TECHNICAL BULLETIN
Bell Helicopter **TEXTRON**

No. 407-05-69

MODEL AFFECTED: 407

SUBJECT: IMPROVED FREEWHEEL AFT SEAL P/N 209-340-265-103, INTRODUCTION OF

Figure 1. Seal 209-340-265-103 - Installation

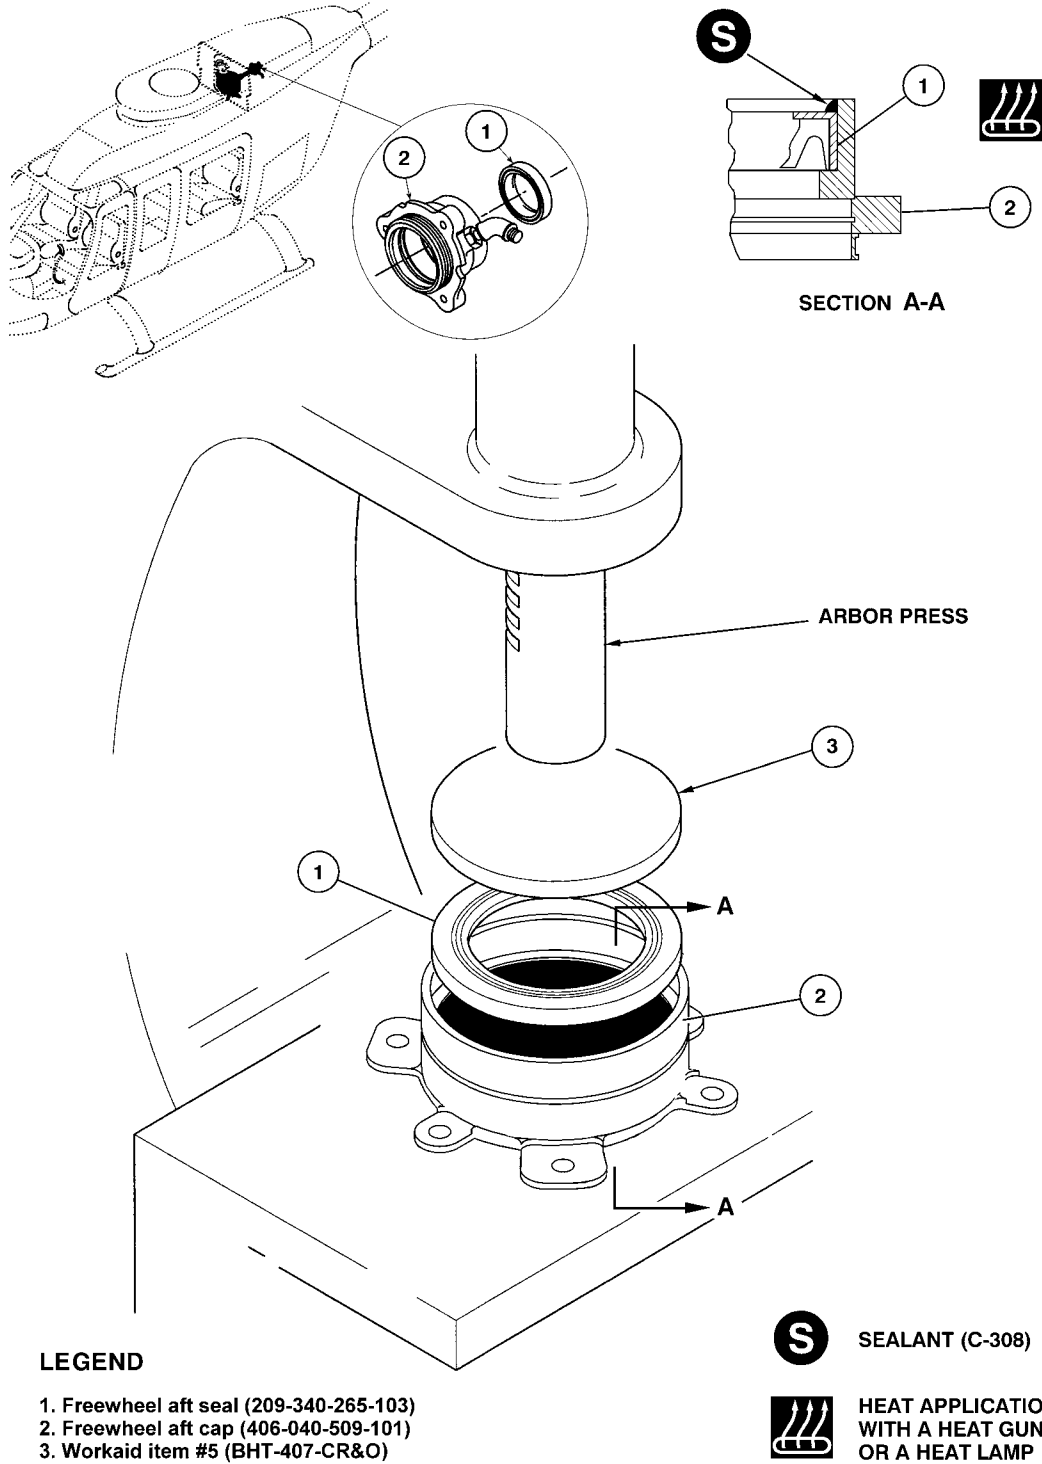
This bulletin is issued to introduce a new freewheel aft seal 209-340-265-103. It is anticipated that this seal will improve reliability and life over the seal currently used.

1. Install the new seal as follows:
 - a. Clean the aft bearing cap (2, Figure 1) with solvent (C-316).
 - b. Heat the aft bearing cap (2) to $250^{\circ}\text{F} \pm 10^{\circ}$ ($121^{\circ}\text{C} \pm 5^{\circ}$).

Do not apply sealant to the outer diameter of the seal (figure) or to the inside diameter of the aft bearing cap.

- c. Press seal (1) into the aft bearing cap (2) with the seal recess facing inboard. Push the seal (1) into the aft bearing cap (2) evenly and smoothly until seated.
 - d. Apply a small beat of sealant (C-308) as shown in figure 1.
2. Complete the installation of the freewheel assembly (BHT-407-MM, Chapter 63)
3. Perform a ground run for 5 minutes at 100% NR and inspect for leaks.
4. Make an entry in the helicopter Historical Record to show that this Technical Bulletin is completed.
